Statutory Review Design Response

Morland Gardens, London Borough of Brent

Following the receipt of comments from GLA, TFL & Brent Highways on the submitted scheme for Morland Gardens, this document has been produced in order to respond to those comments and show how the scheme has been amended.

1.
Greater London Authority - GLA/5444/01 - 09.03.2020
(GLA Comments)
2.
Transport For London - BRNT/20/7 - 20.03.2020
(TFL Comments)
3.
LBB Highways - D91/1324EP/1 - 25.03.2020
(LBB Highways Comments)

Entrance level of Adult Education on the upper ground floor

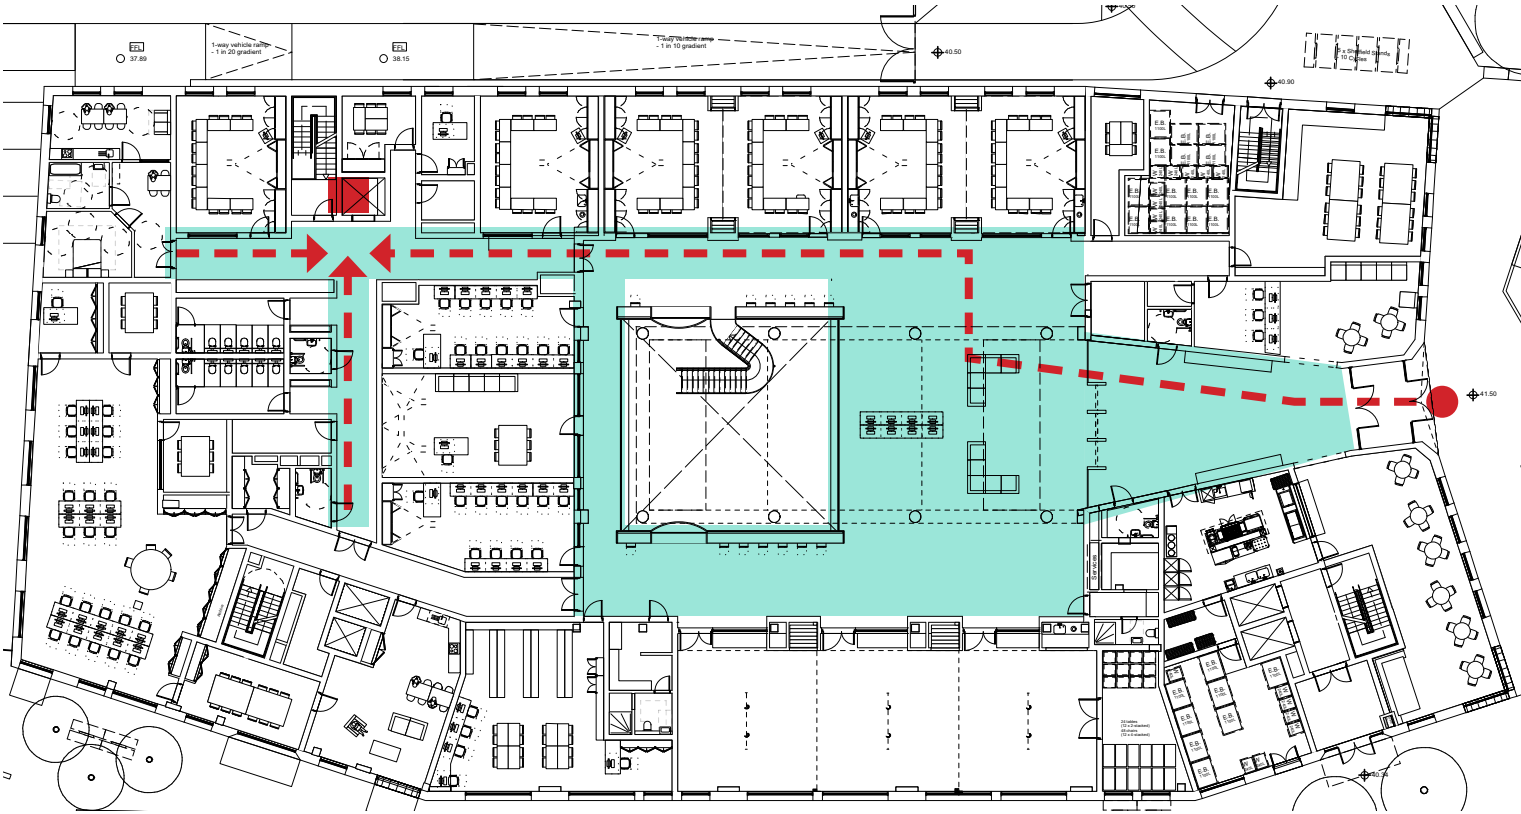
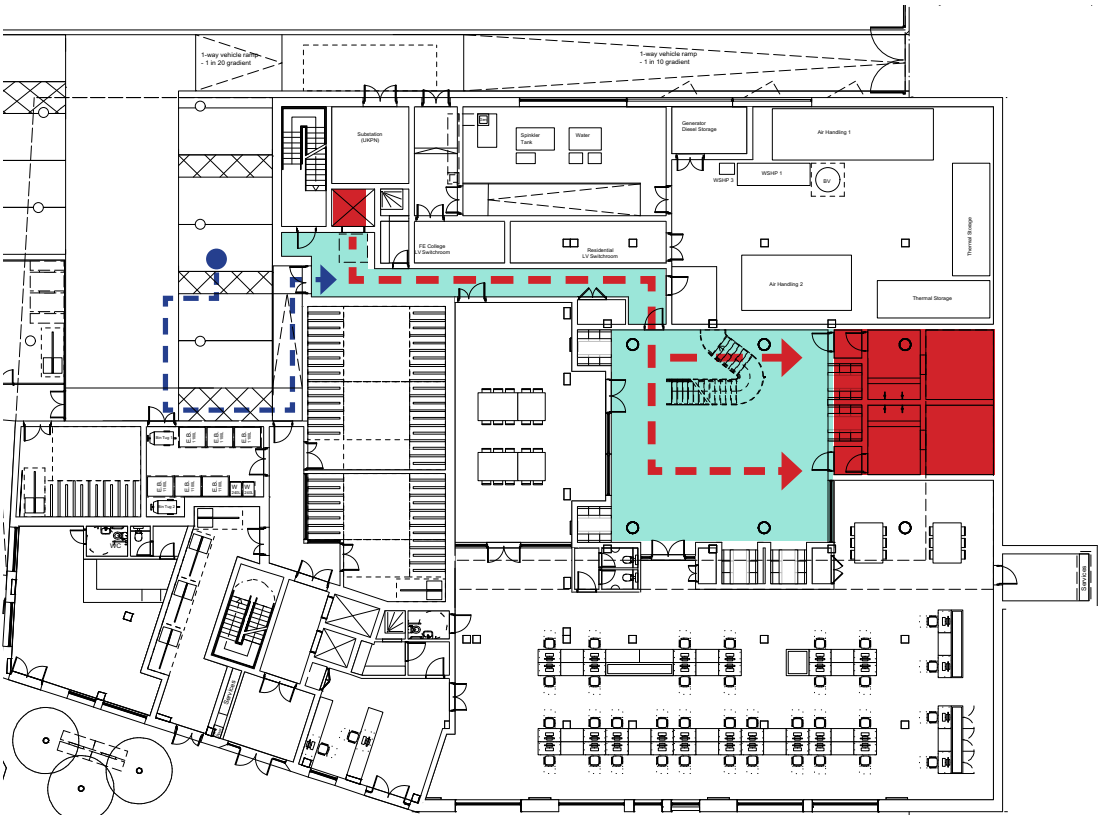
'It is not clear how wheelchair users can access the multi-faith rooms; a lift is shown between lower ground and upper ground floors and the applicant should clarify if this is for general use.'

The Multi-faith spaces of the Adult Education Centre will be accessed from the lift in the north west corner of the building by users with limited mobility. It is not inteded as a goods lift but is for general use purposes.

This lift will also enable wheel chair users of the Adult Education Centre to arrive by car in the lower ground level and access the primary level.

Drg Title Hardworks Plan-Ground Level

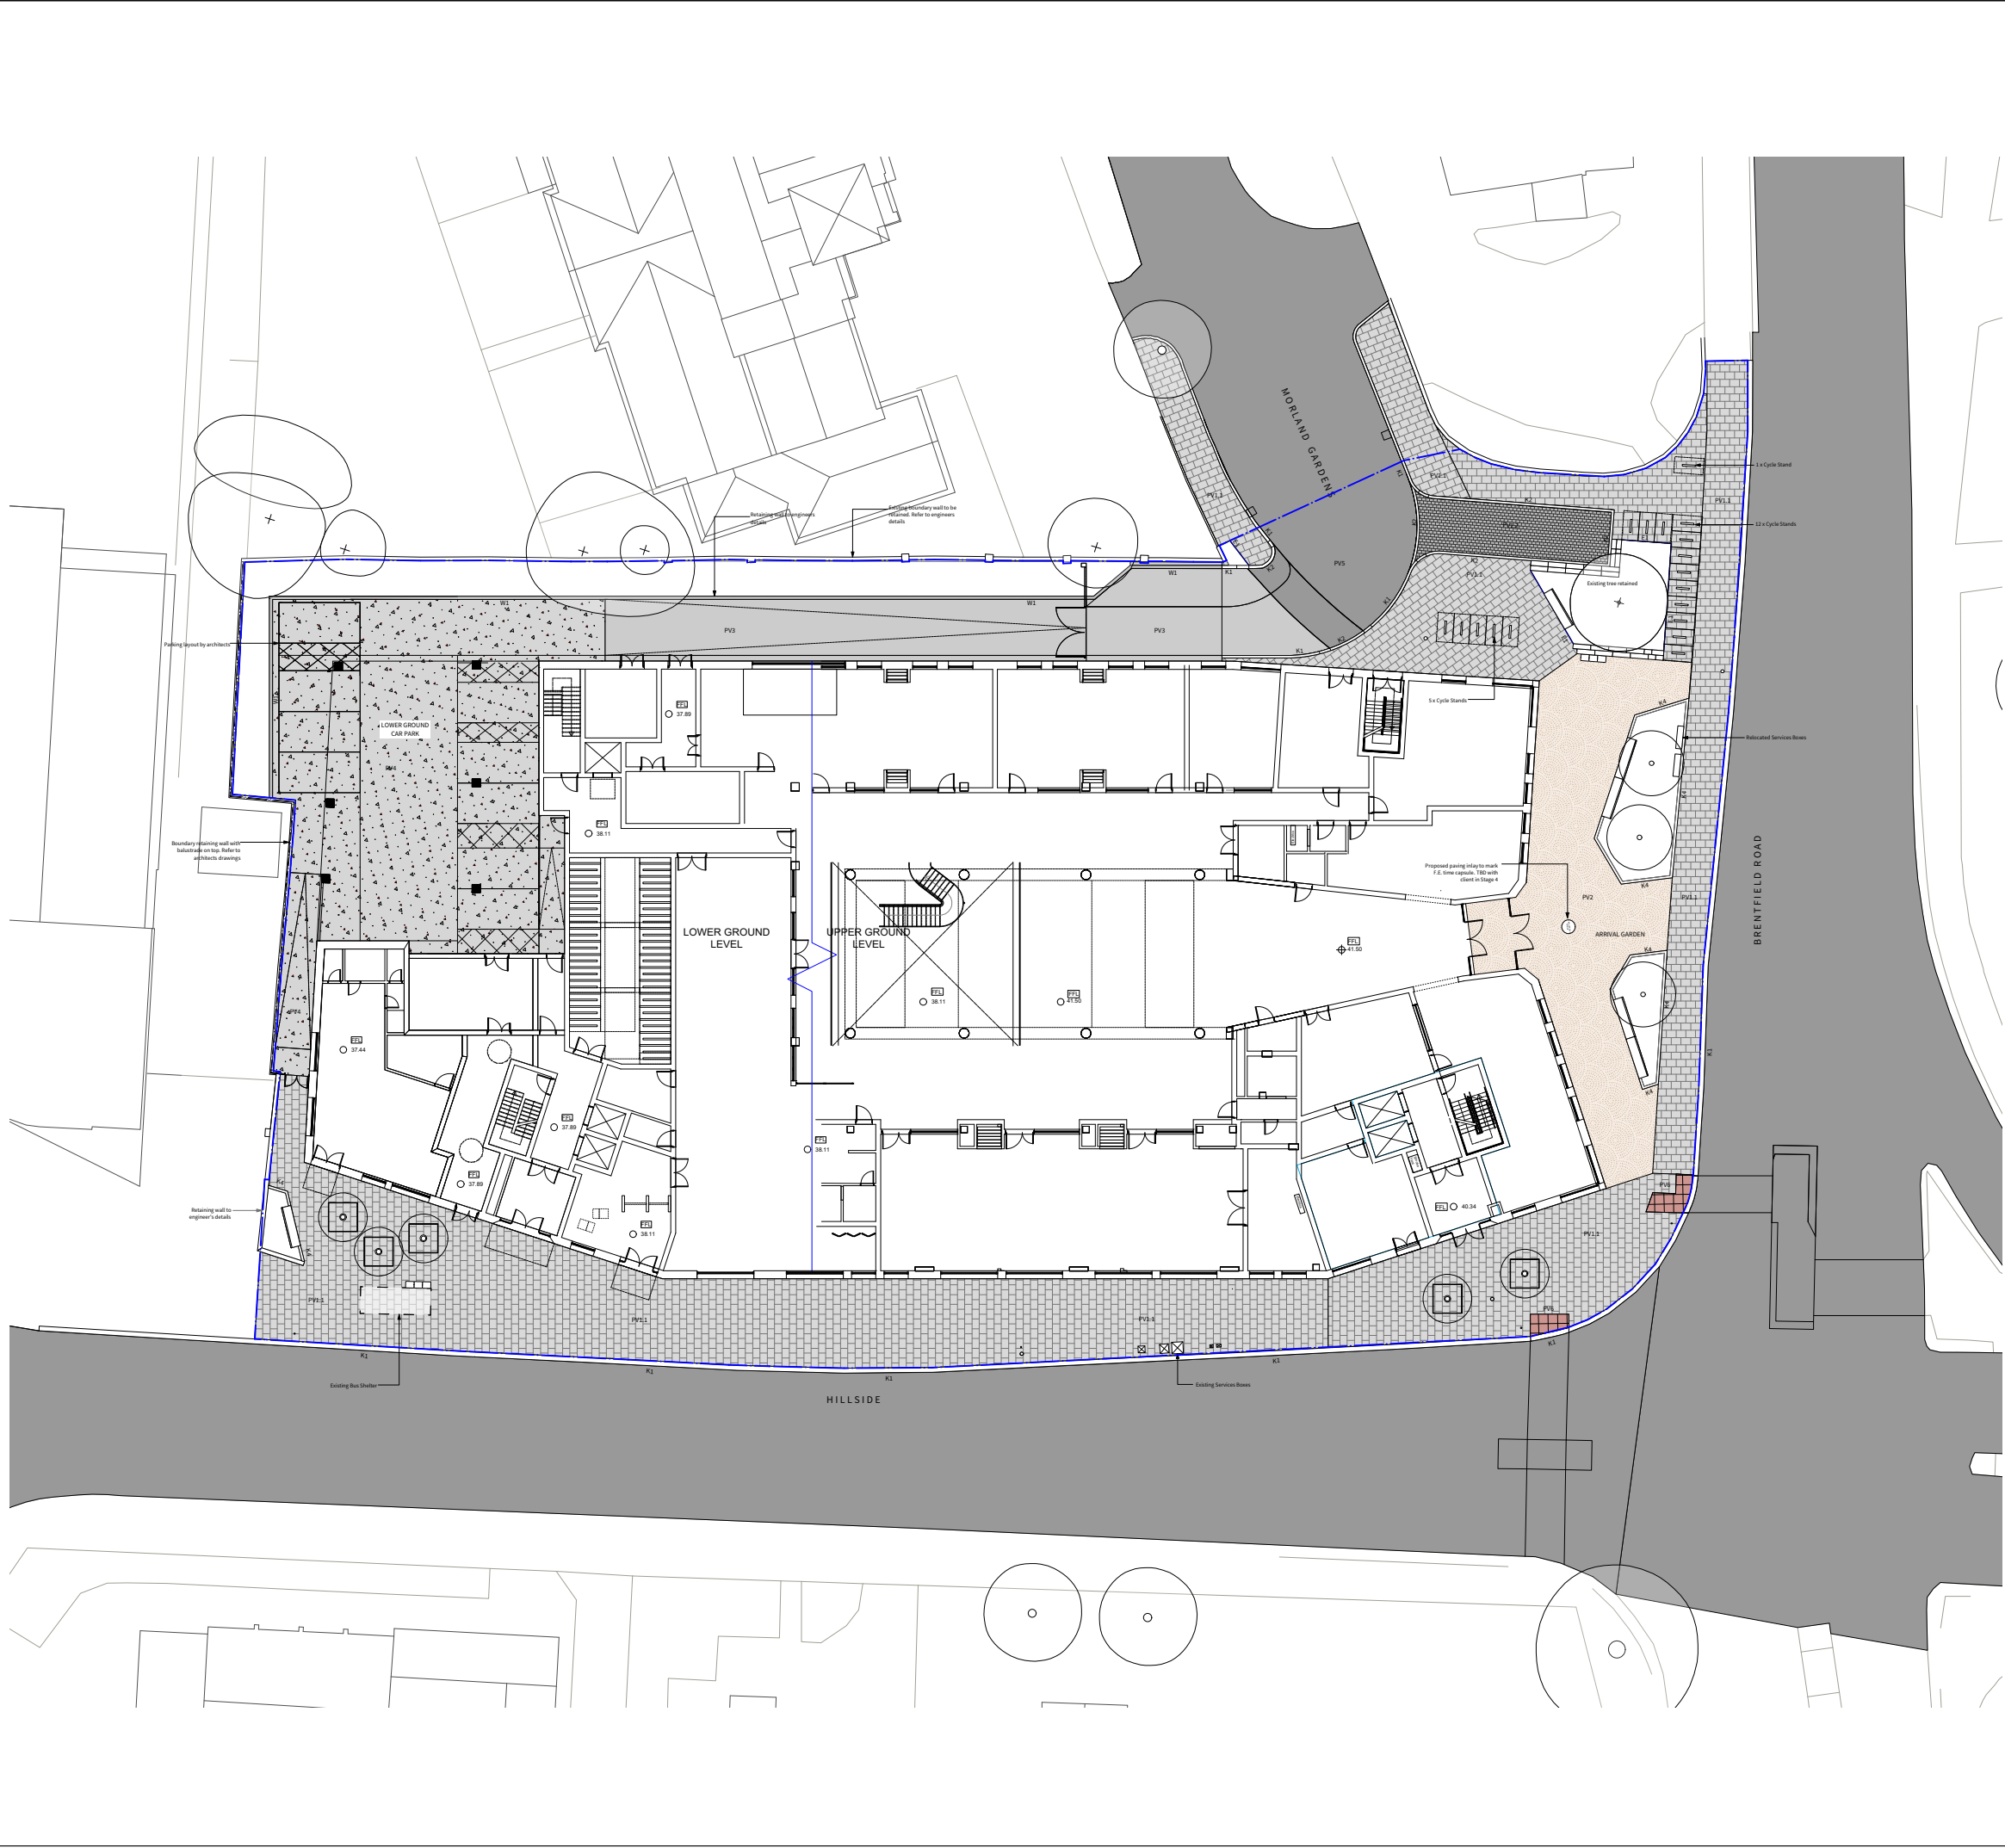
49 ‘The applicant should provide the UGF score for the development with the aim of meeting the target of 0.4 for predominantly residential developments as set out in the Mayor’s Intend to Publish London Plan Policy G5. A drawing showing the surface cover types and accompanying UGF calculation should be submitted.’

The UGF has bee calculated on this page in the adjacent column and drawings demonstrating how these figures relate to the proposed drawings are provided on the following pages.

THe UGF cacluated as 0.2 and thus falls short of the target of 0.4. However, the scheme has been separately commended for its provision of roof top gardens in a dense urban location that does not give opportunities for extensive greening at ground level.
